ADDENDUM 3

NOTICE TO BIDDERS: Amend the Project Manuals and Drawings to the above referenced project as follows:

ELMIRA HIGH SCHOOL
FERN RIDGE SCHOOL DISTRICT
ELMIRA, OREGON

DLR GROUP PROJECT NO. 74-13107-40
ADDENDUM 3
MARCH 25, 2016

Attachment No. SK-A1
to ADD 3
Dated: 3/25/2016

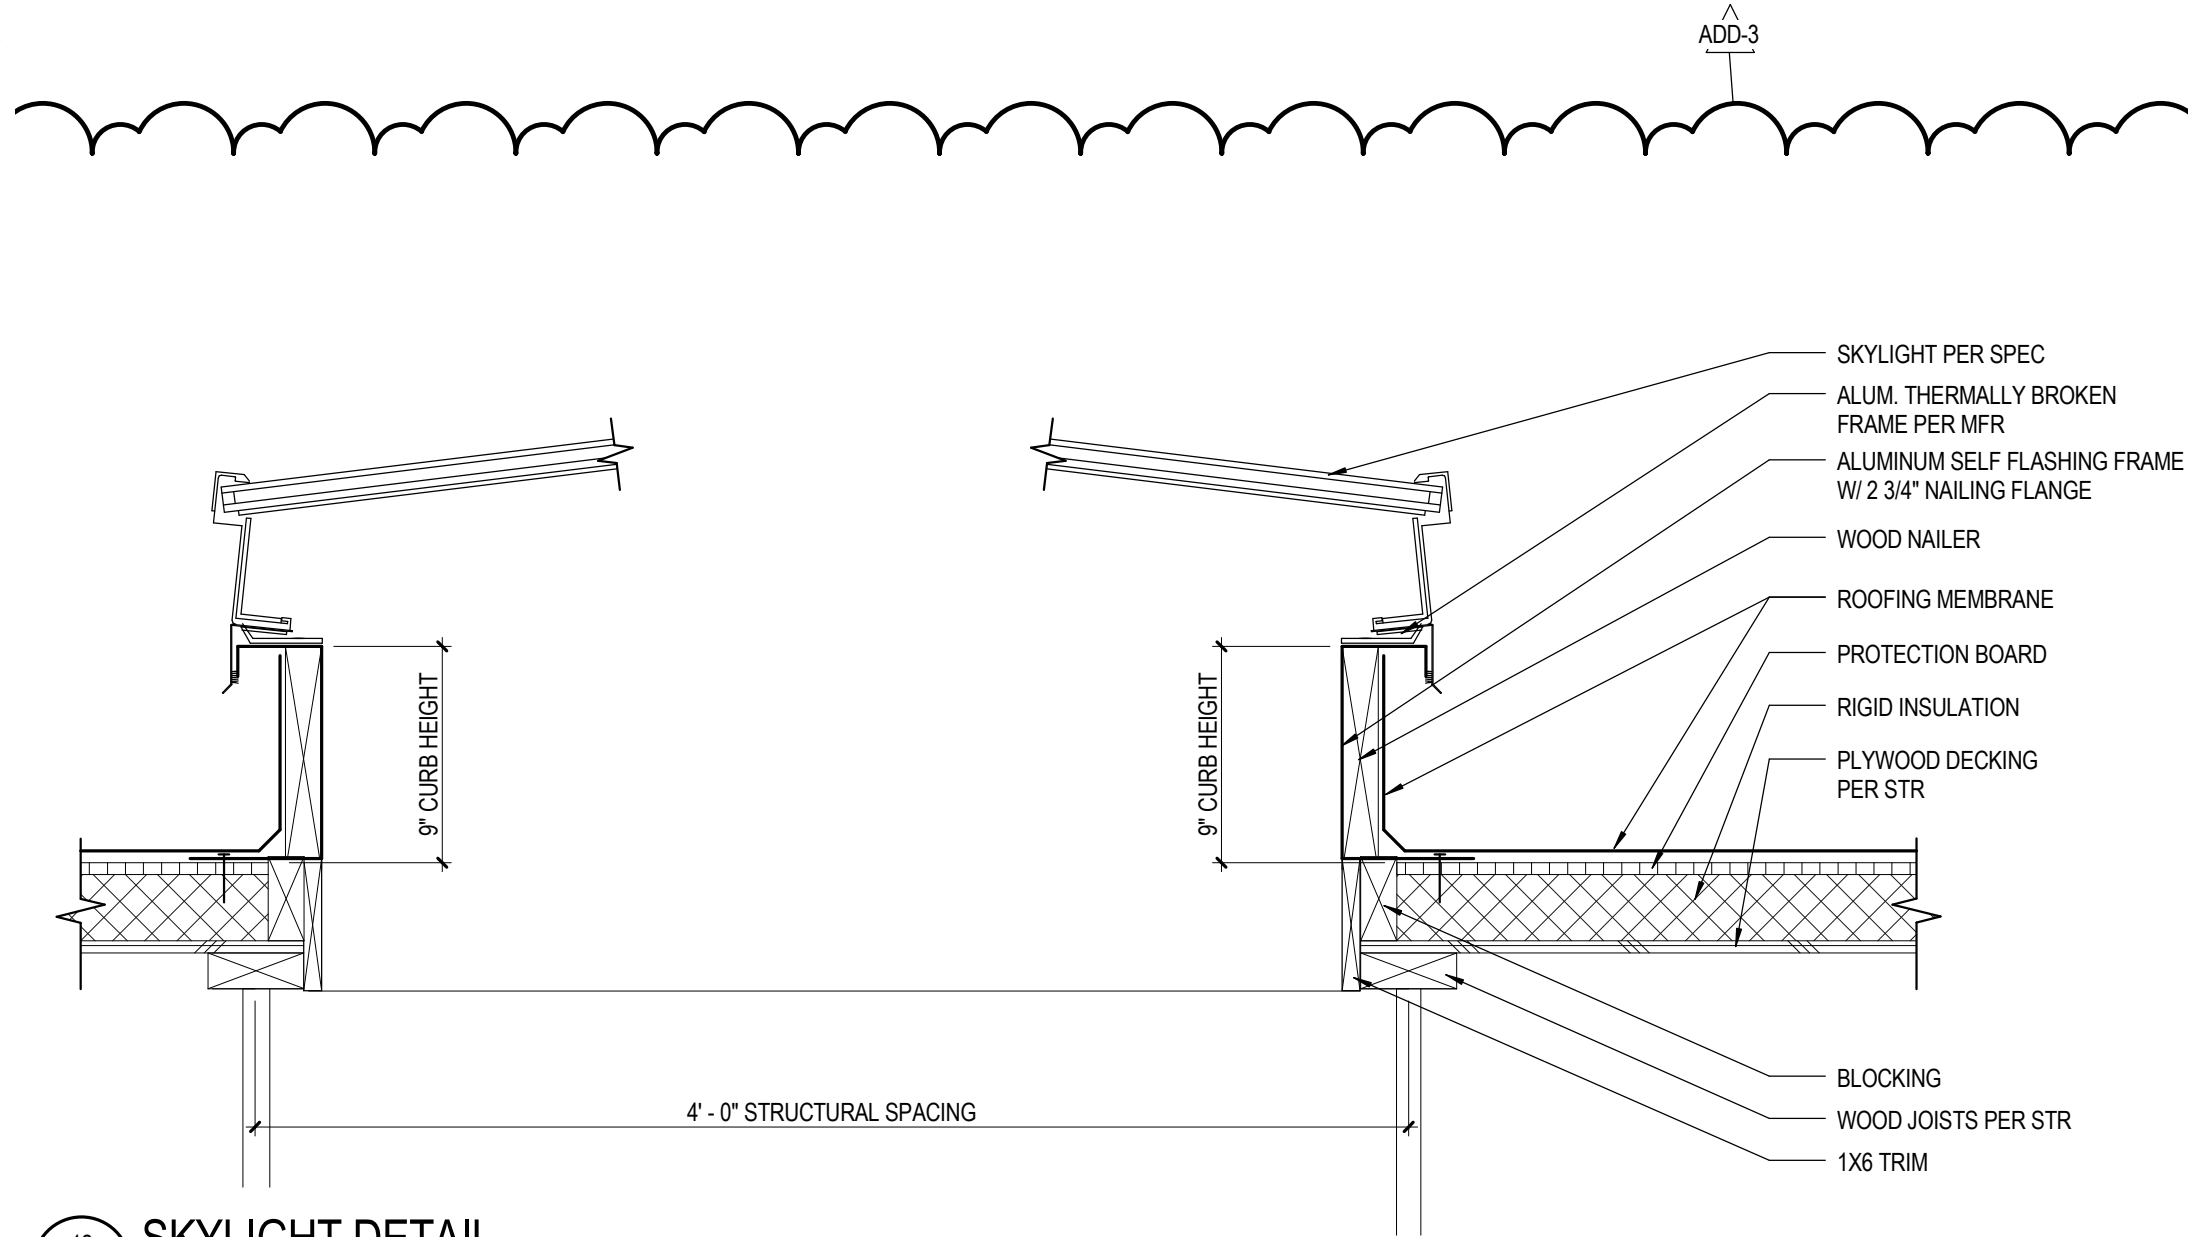
- A. KEYNOTES: Revise to include OFCI (Owner Furnished, Contractor Installed) items and add sanitary napkin dispenser and toilet seat cover dispensers per attached SK-A1.

12 SKYLIGHT DETAIL
A4.2. SCALE: 1 1/2" = 1'-0"

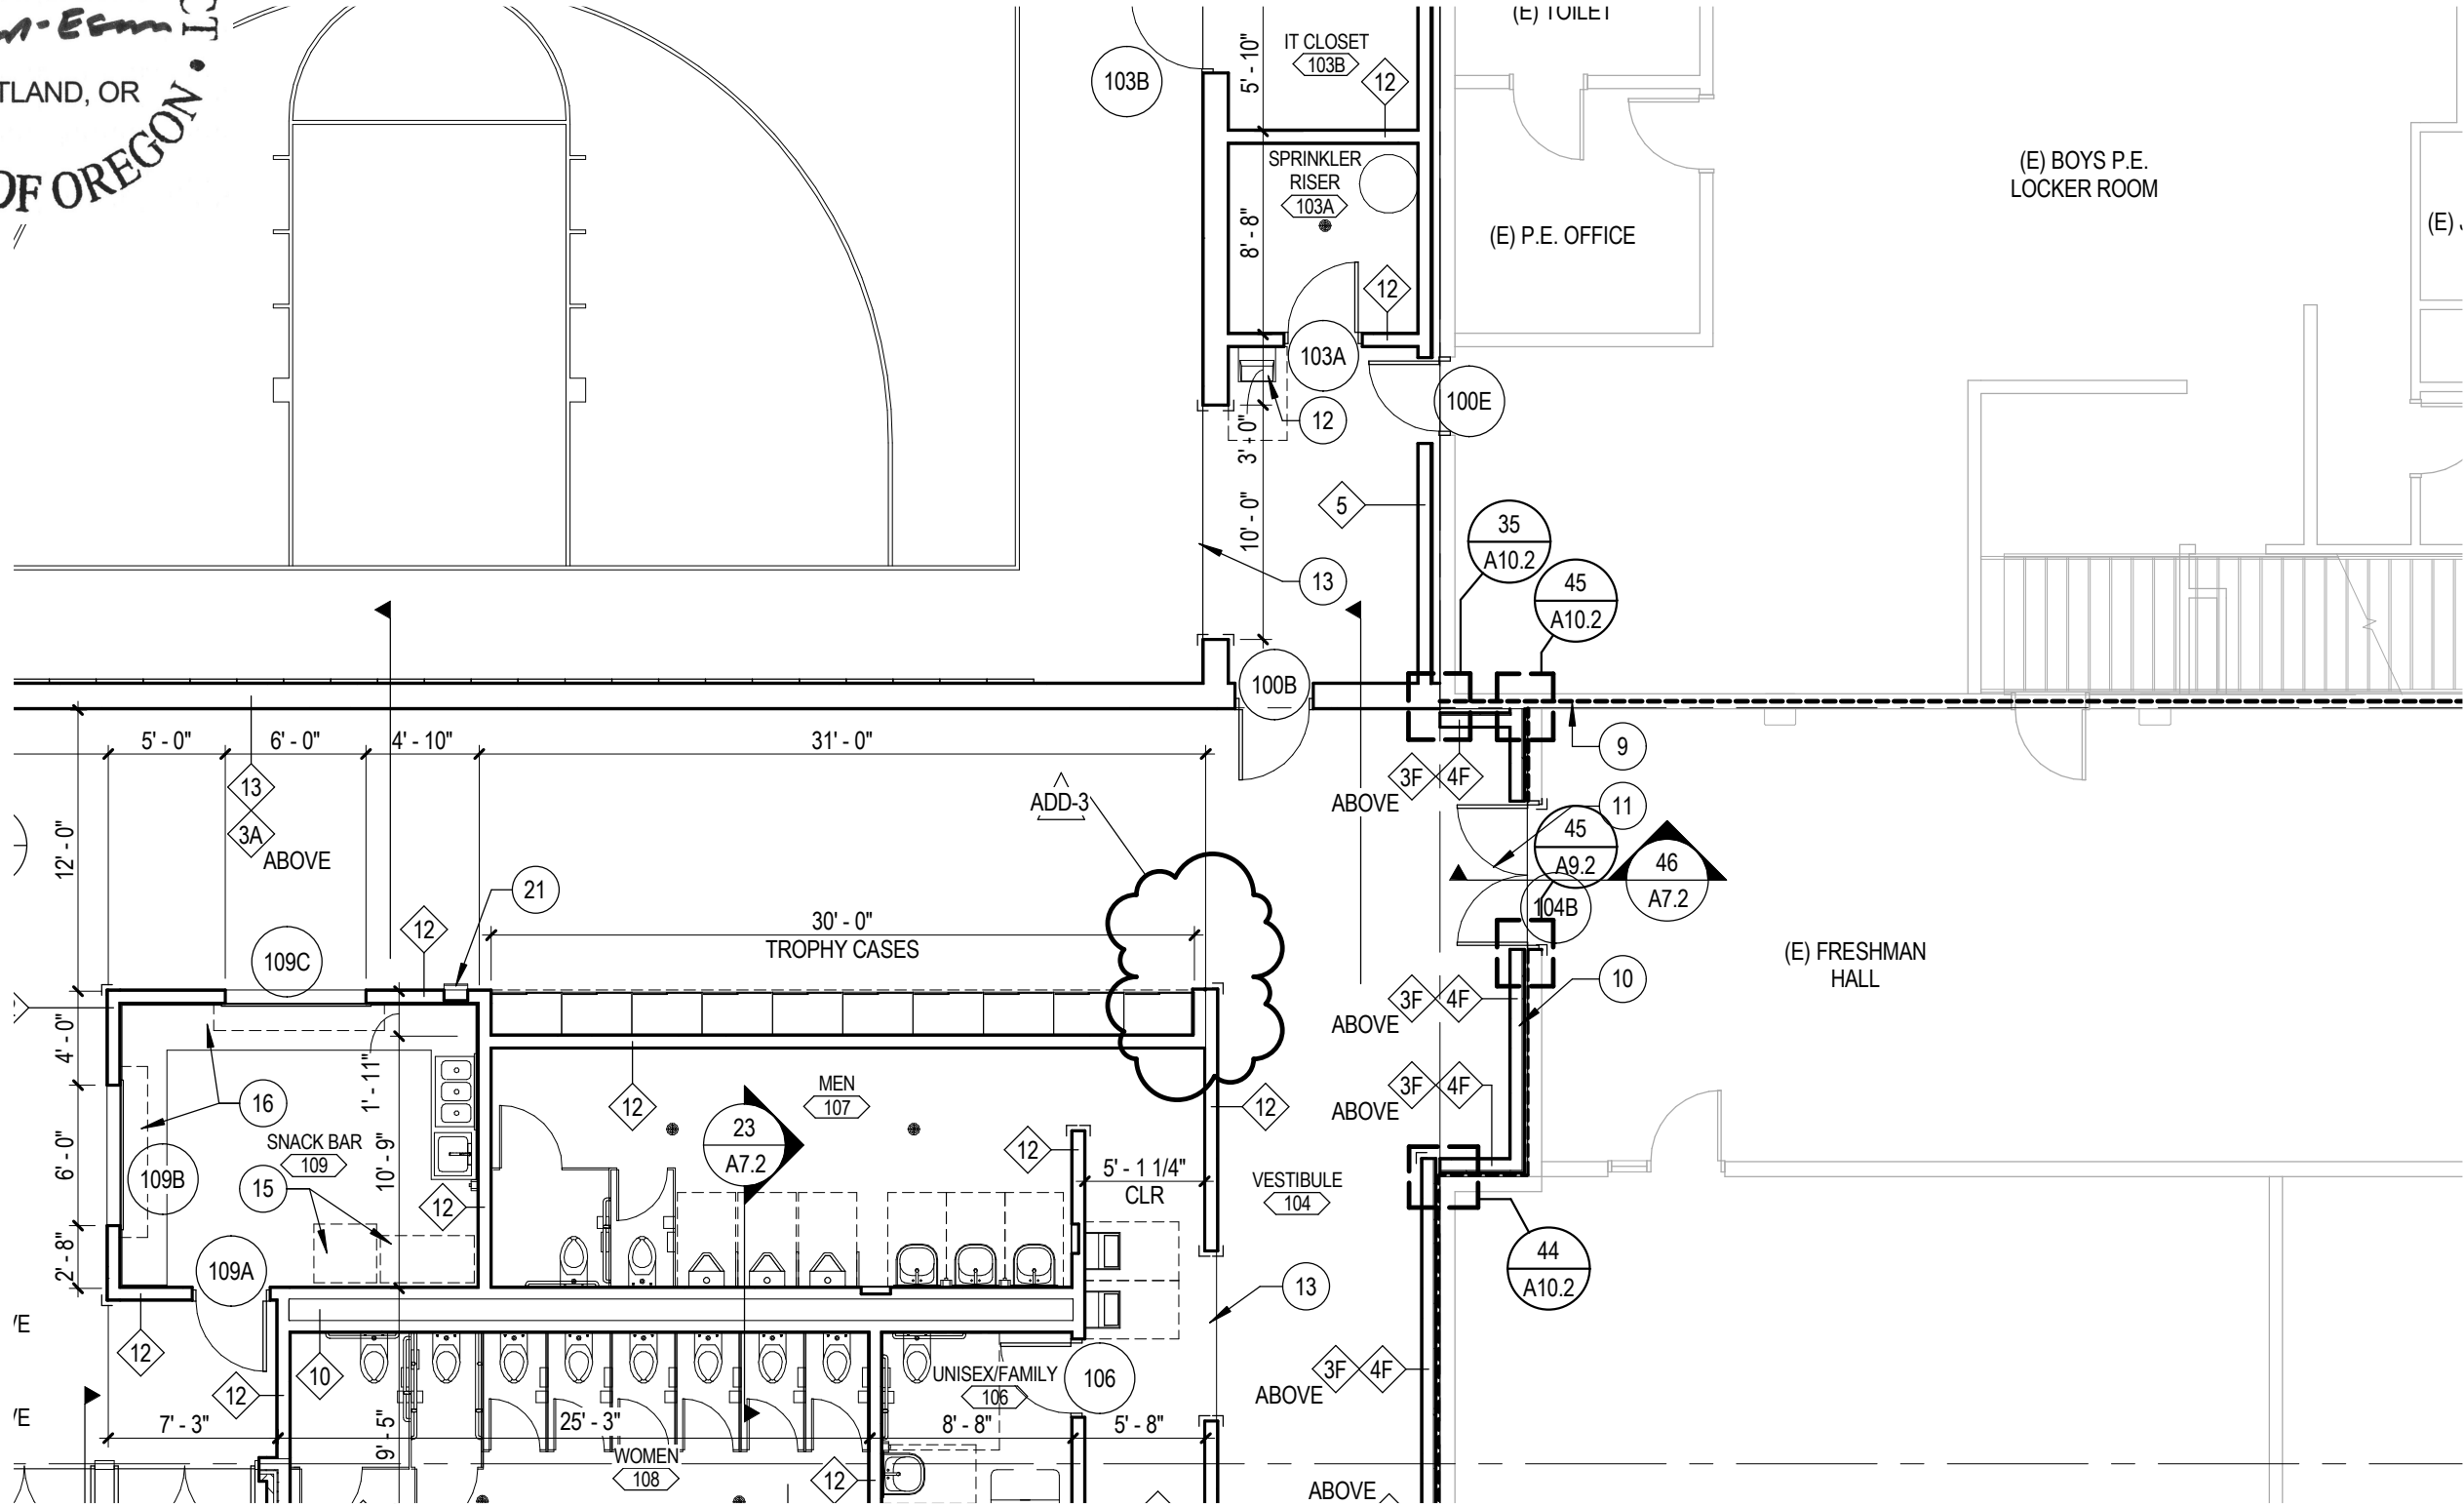
- A. Remove and replace detail 12 Skylight Detail per attached SK-A2. (Also see corresponding added specification section from this addendum.)
